**WHEELING PLAN COMMISSION
THURSDAY, SEPTEMBER 13, 2018 6:30 P.M.**

**AGENDA FOR A REGULAR MEETING OF THE PLAN COMMISSION
Board Room - 2 Community Boulevard, Wheeling, Illinois**

RE: **Docket No. PC 18-15**
Pizza Roncadin
236 Egidi Drive
Minor Site Plan and Appearance Approval of a Nitrogen Tank

RE: **Docket No. 2018-23**
H2O Express Car Wash
966 S. Milwaukee Avenue
Special Use-Site Plan Approval of a Car Wash Facility

SITE PLAN AND SECTION

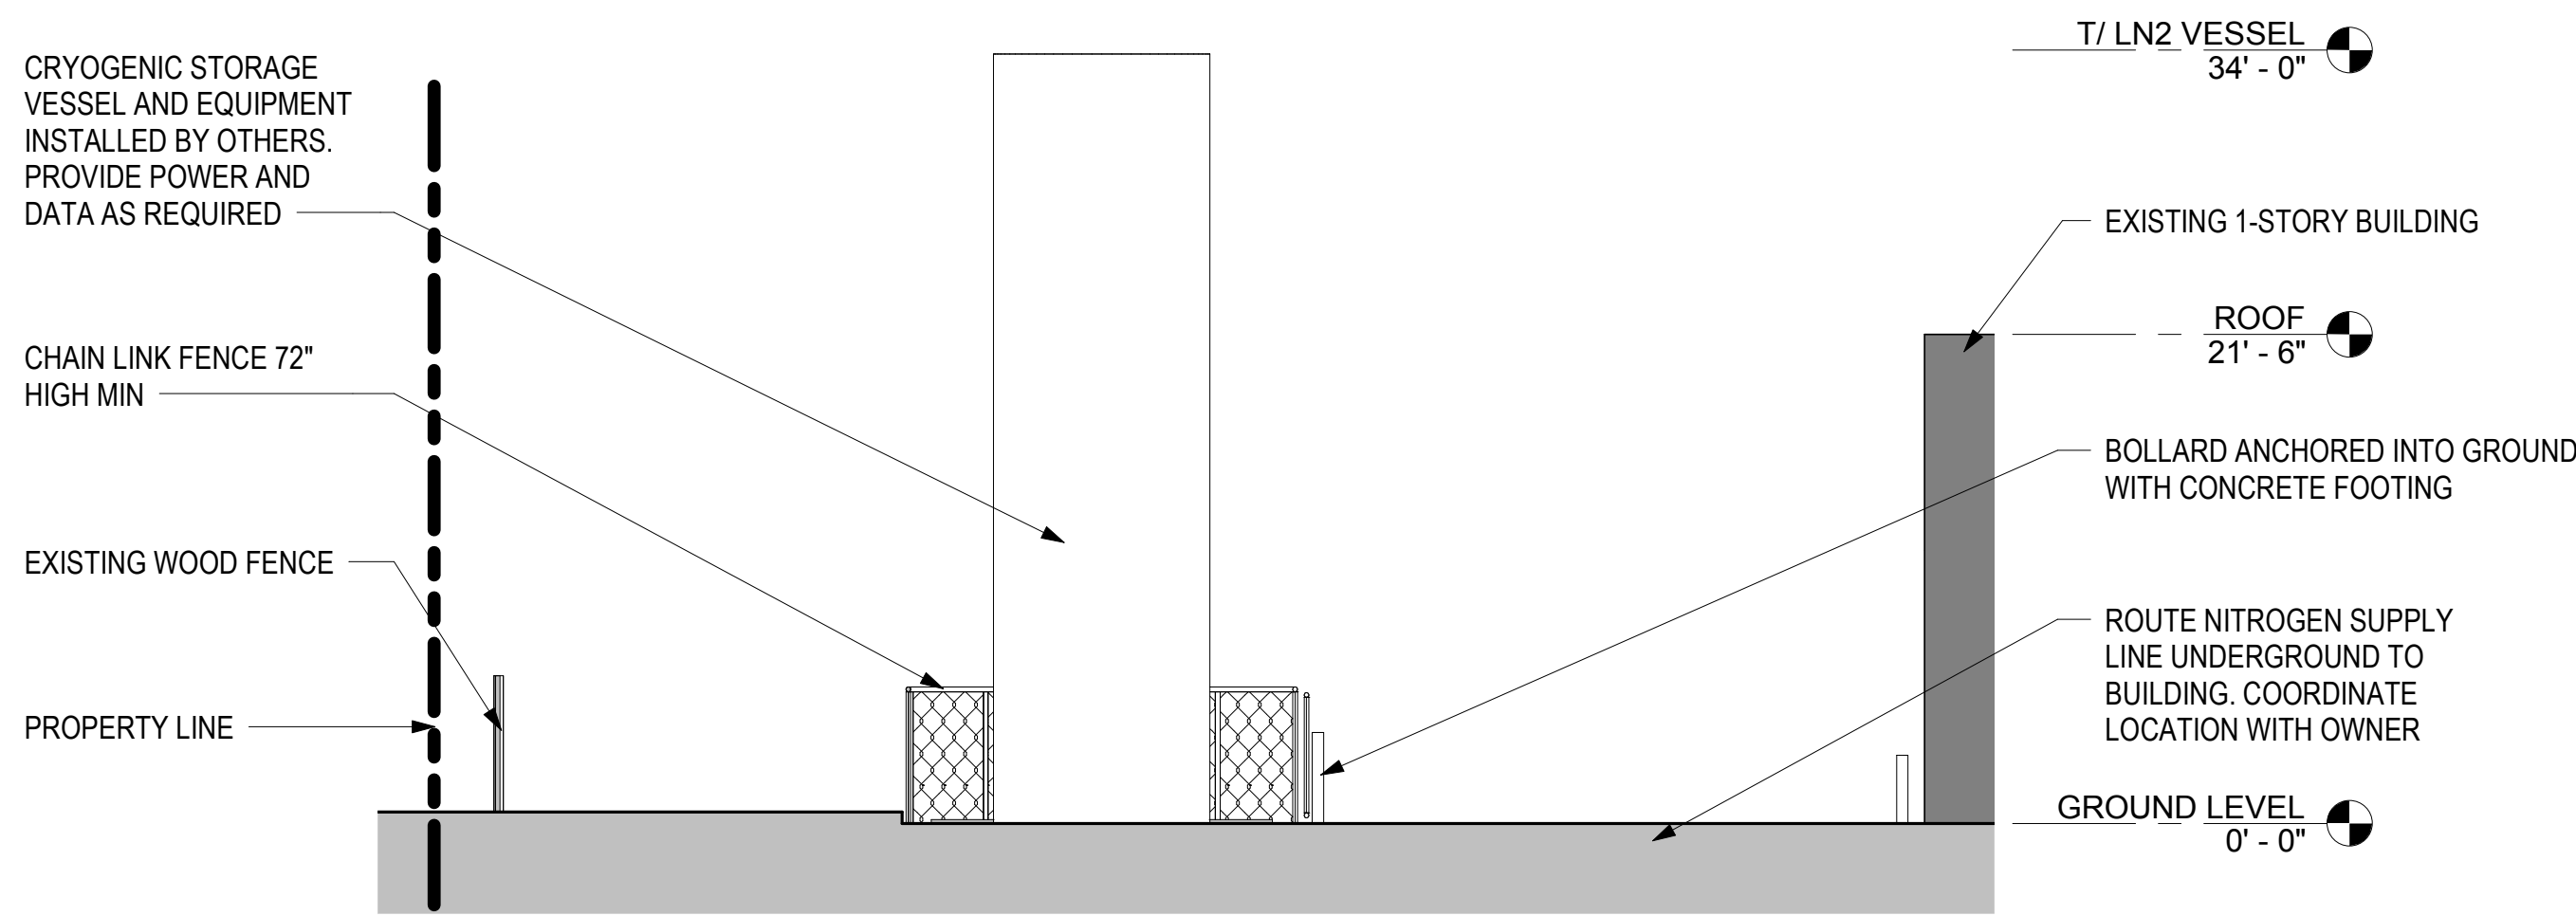
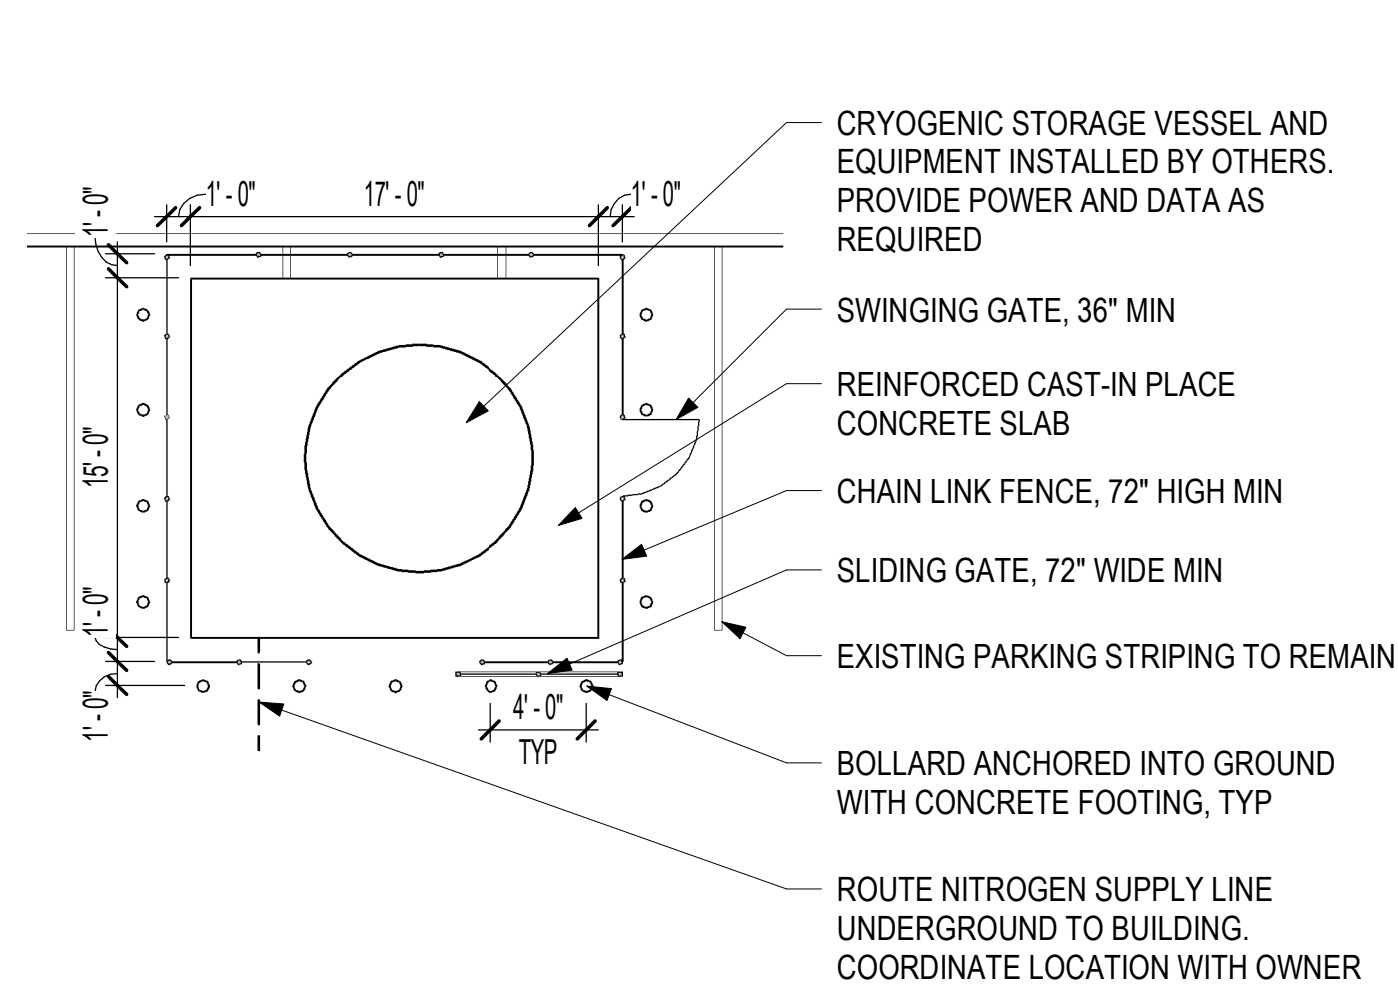
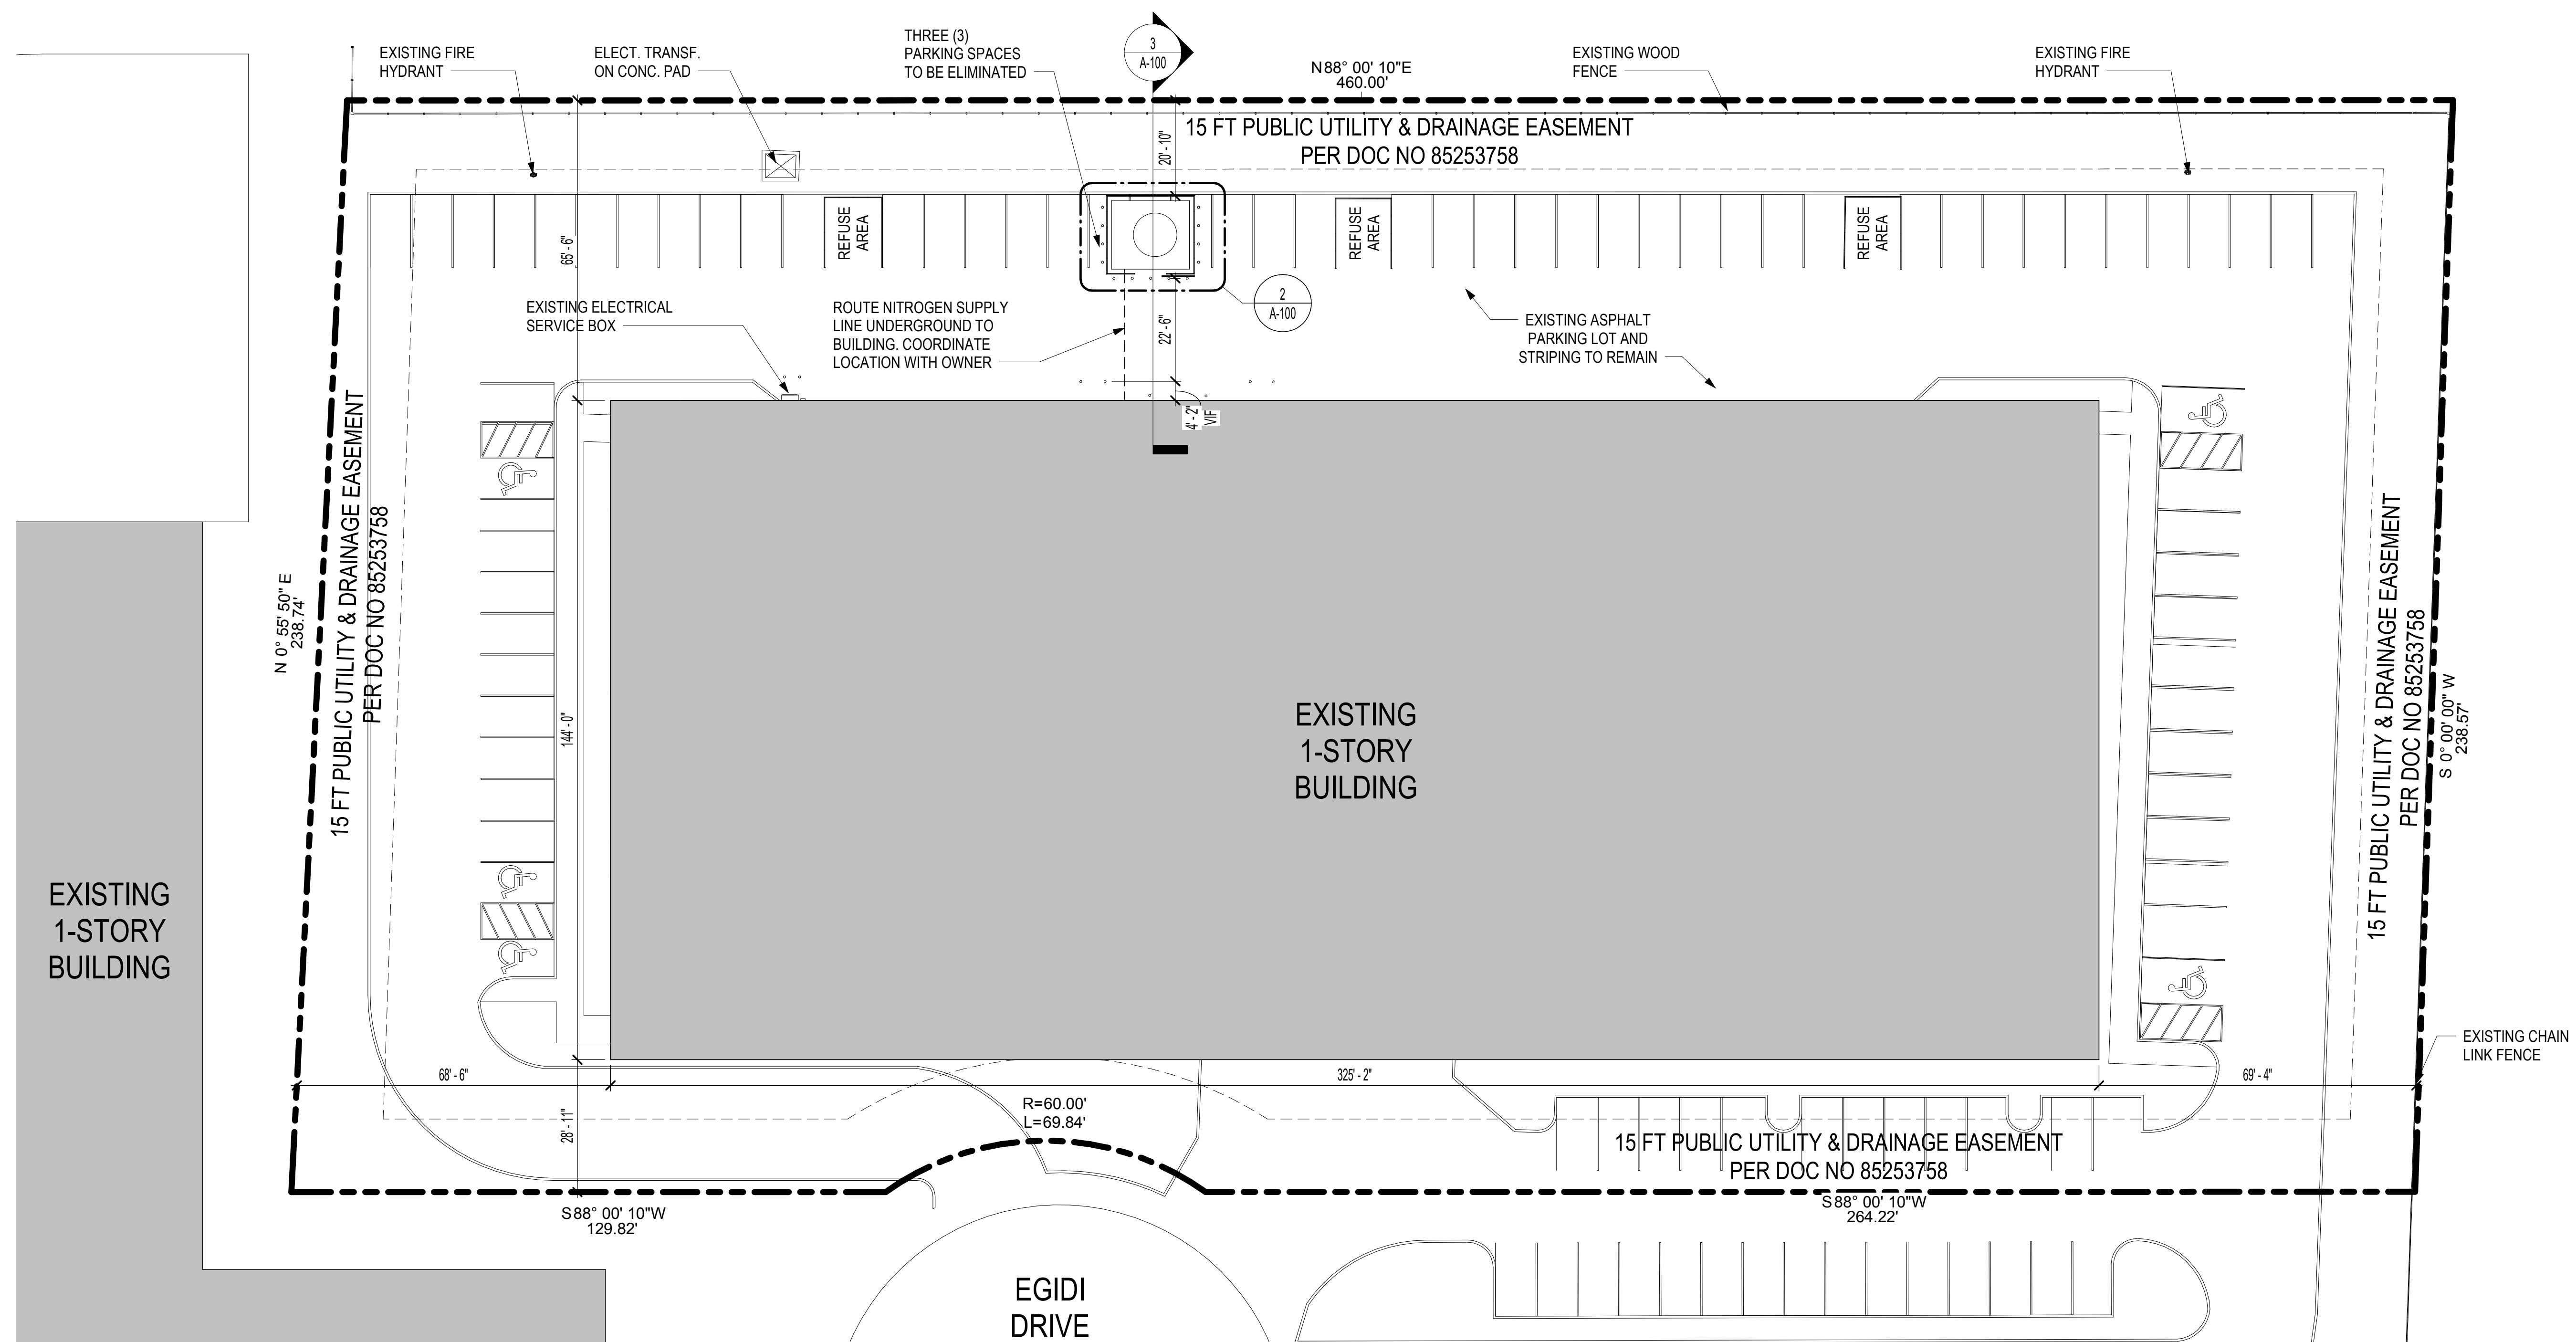
Structure height: The proposed tank is 34 feet in height. Accessory structures may have a maximum height of 20 feet for the I-1 District. However, according to Section 19.03.060 of the Zoning Code, the Plan Commission may grant exceptions to the height limitations for “church spires, belfries, and domes not intended for human occupancy; monuments, water towers, *transmission towers*, utility poles, chimneys, *masts* and aerials, standpipes, similar *structures*, necessary mechanical *appurtenances* and their accessory screening, as part of *special use* review and approval, or as part of a site plan and appearance approval if special use review is not required.”

The Plan Commission should make a determination if the height of the proposed structure is acceptable at the proposed location.

Impact on adjacent uses: The Plan Commission should make a determination if the height of the proposed structure is appropriate for the proposed location.

Staff Recommended Action: If the Plan Commission has determined that the tank height is appropriate, then staff recommends approval of the minor site plan modifications.
